Re Planning Application Ref; D26A/0481

Proposed Development letter of Appeal to An Coimisiun Pleanala

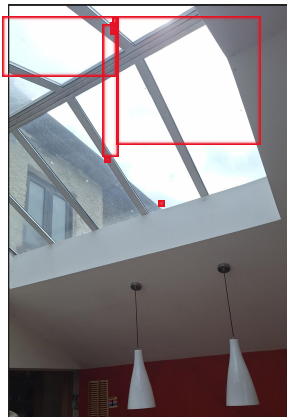
The dormer part of the rear roof should be similar to the character of the front dormer, where it set back from the eaves, should be stepped down from the ridge, and should be set in equally on both side of each gable party wall to sit comfortably within the slope of the existing roof plane (not overtake it).

The dormer should not be pushed to one side where it impacts unfairly on one neighbour over another on the opposite side. Dimensions should be specific to being external, with at least 1.2m distance externally from the party wall as indicated on rear elevation drawings submitted for the south side of the dormer (this is similar to the distance shown for the front dormer) The dimensions should be to the inside face of the party wall to avoid any disruption to the structure or roof tile finish to No.17.
